I am writing to comment on draft Regulatory Guide DG-8015, "Release of patients administered radioactive materials." (1)

7/1/94
 Douglas J. Simpkin
 Comment on Reg Guide DG-8015

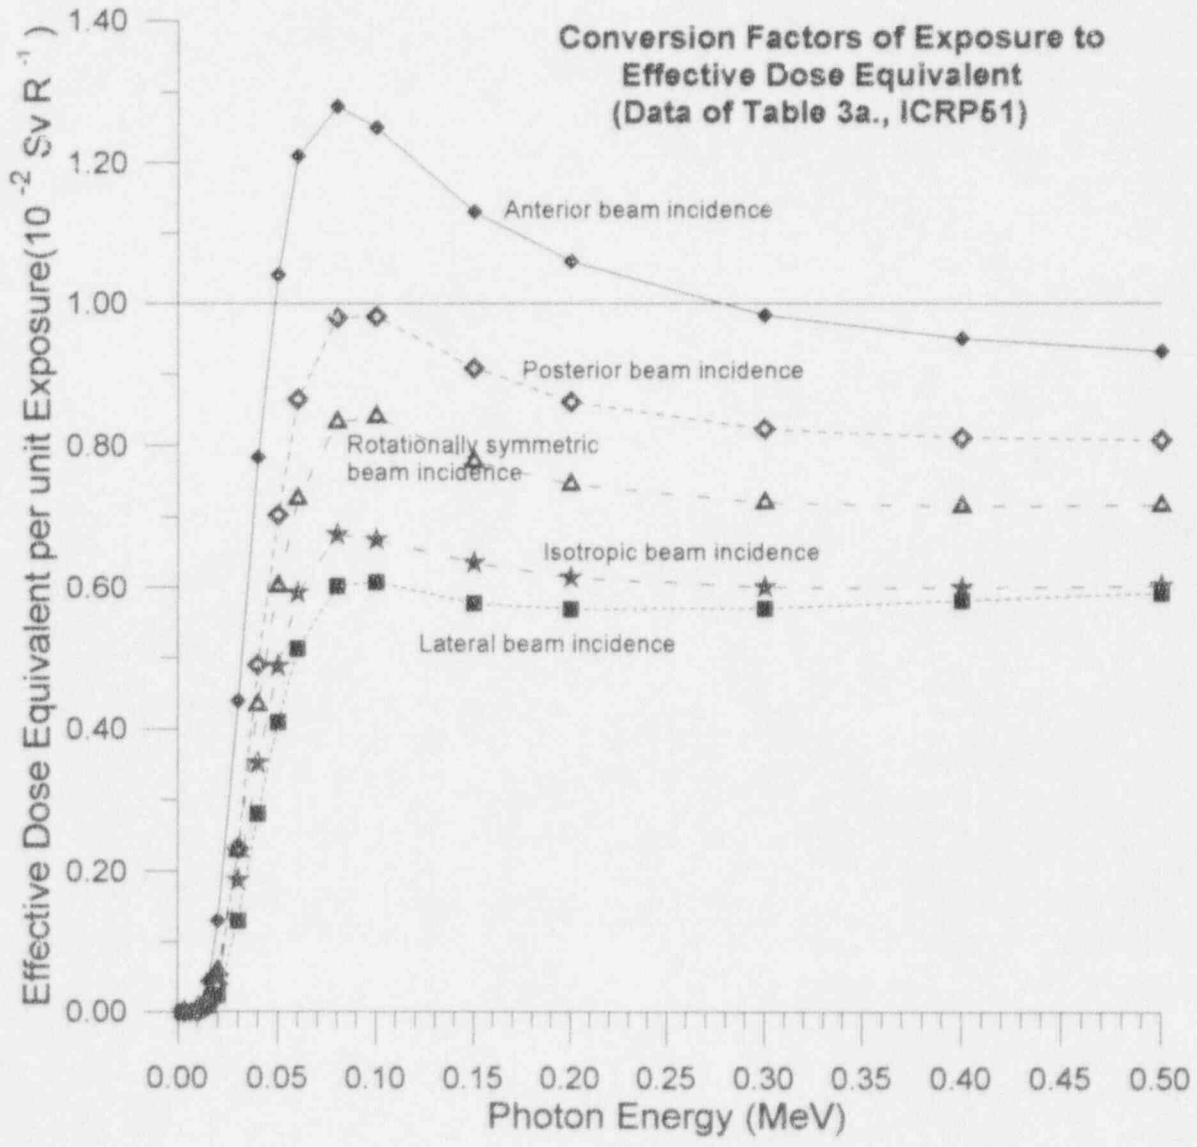
While I generally agree with the spirit and procedures in the draft regulatory guide, I would like to remind the Commission that low energy photons will be attenuated not only in the body of the patient, but also in the overlying tissues of an irradiated bystander. The exposure calculated in Appendix A of the draft guide may therefore exceed the effective dose equivalent, depending on the orientation of the bystander in the photon beam. Table 3a of report number 51 of the ICRP has conversion factors from exposure in R to effective dose equivalent in 10^{-2} Sv (that is, rem). I enclose a graph of this data. The graph shows that effective dose equivalent, H_E , is greatest for anterior incidence on the bystander at all energies. For a photon beam that exposes the bystander randomly from all sides, H_E is $\sim 3\%$ below that for anterior incidence.

Please note the very sharp rise in the curves of H_E per exposure at low photon energies. In the 25-35 keV range of ^{125}I photon emissions the H_E in rem is not more than half that of the exposure in R for anterior incidence and $\sim 1/4$ of that for rotational symmetry. Lower energy scattered photons emanating from the patient will only lower this conversion of exposure to dose.

I therefore submit that an additional factor of $1/4$ to $1/2$ may be conservatively multiplied onto the equation for dose from ^{125}I (Equation A-10 in the Regulatory Guide).
